Access Compliance Report Public Rights-of-Way (Curb Ramps)

Main Street: WINTHROPE_ST		Cross Street: WINTHROPE_ST		Location:	SE
ADA ID: RPAT211006134332	Ramp Type: Type 6 - Directional 1	Initial Pass/Fail: Pass	Overall Compliance: No	Severity Score:	15
Codes/Mitigation Info/Possible Solution			Field Measurements/Component Compliance

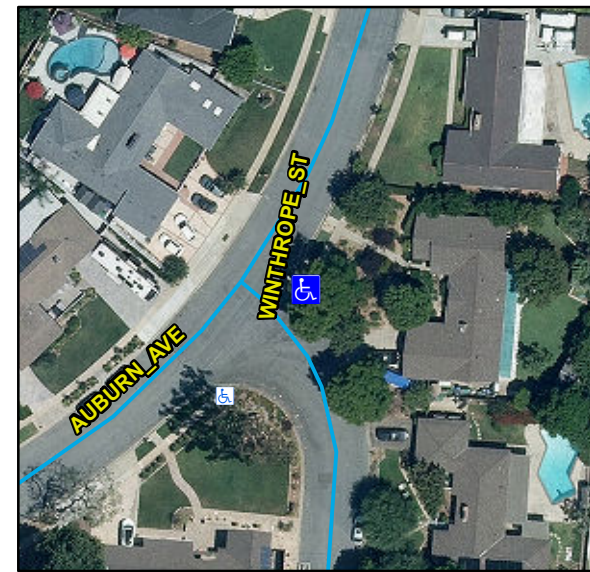
Remove & Replace Curb Ramp With Two New Directional Ramps or Equivalent. Gutter Ponding Observed.
